## **Building Consistency Meeting**

### Residential

Date: 7/2/2008 Recorder and minutes prepared by: Danny Wooten/Jeff Griffin

Code change proposal for Bowed stair treads to read as follows:

**Figure R311.5.8.3**

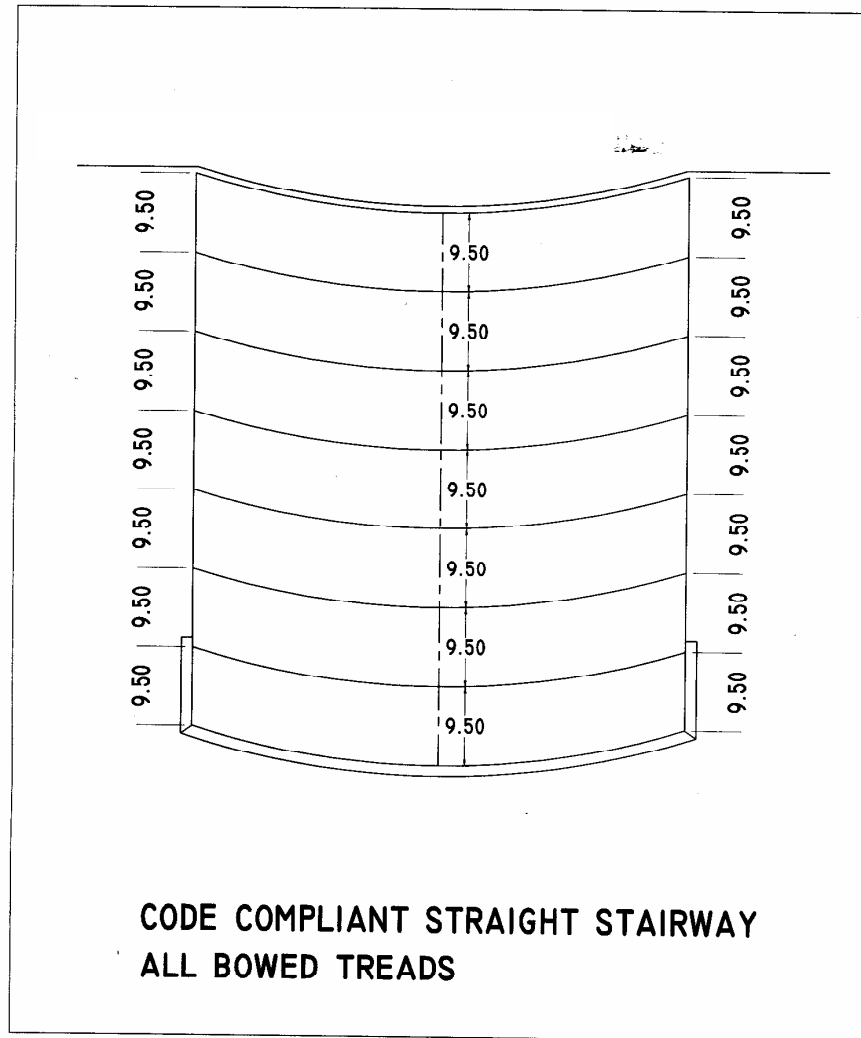
**All treads in a straight run stairway can be bowed but must be uniformed for the entire flight of the stairway. Landing at top will be required to bow as well to maintain uniformity at last tread. Each tread must maintain a uniform arch to each tread surface for the entire width of the tread with no more than 3/8" variance from greatest to least within the stair flight.**

**R311.5.8.3 Bowed tread stairways.** Bowed tread stairways are permitted provided they are uniform in bowed tread depth along entire width of tread with not more than 3/8" variance from greatest to smallest tread in the stairway flight. At no point shall the tread be less than a minimum of 9 inches with a nosing as listed in section R311.5.3.2 and R311.5.3.3 respectfully.

**Figure R311.5.8.3.1**

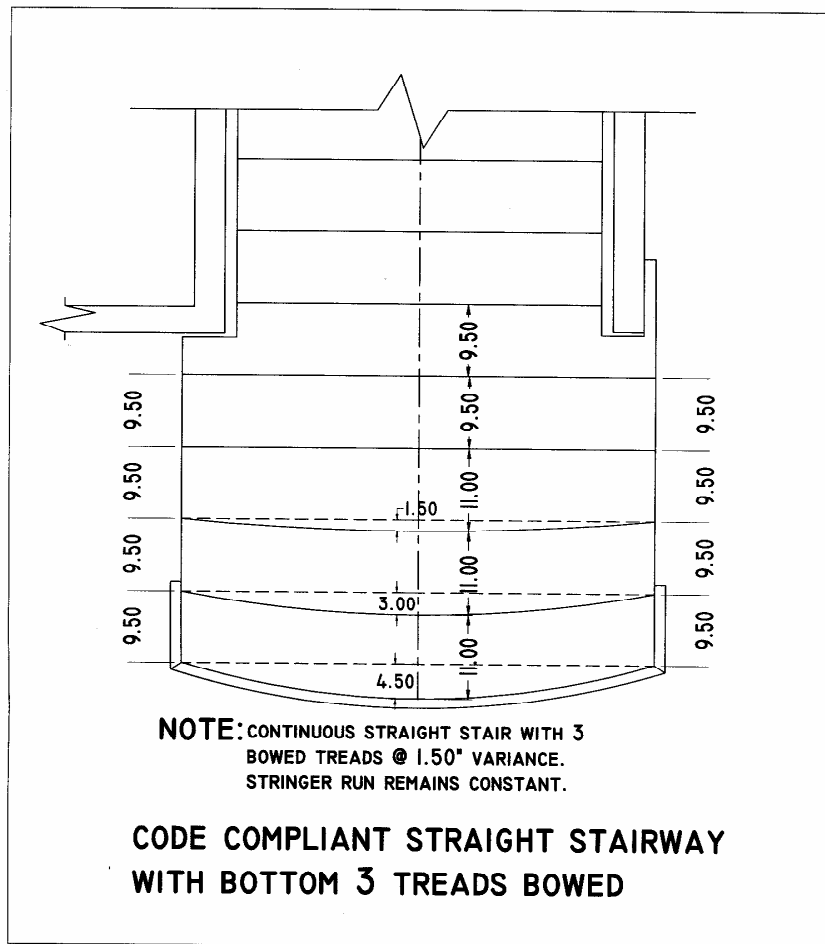
The use of a bowed tread in a standard straight run stairway with rectangular treads is allowed but only in the bottom 3 steps within that flight. Each bowed tread must be uniform with the other bowed treads but not with standard rectangular treads within that flight. No area of bowed tread surface can be less than 9" as measured under section R311.5.3.2 and a nosing is required unless all of the bowed tread surface is greater than 12" as listed under section R311.5.3.3.

**R311.5.8.3.1 Standard stairway application.** The bottom 3 treads in a standard stairway application as listed under section R311.5.3.2 are permitted to bow provided at no point along the width of the tread they are less than 9" as measured under section R311.5.3.2 and each bowed tread is uniformed with other bowed treads with no more than 3/8" variance from greatest to least. Nosing is required as listed in section R311.5.3.
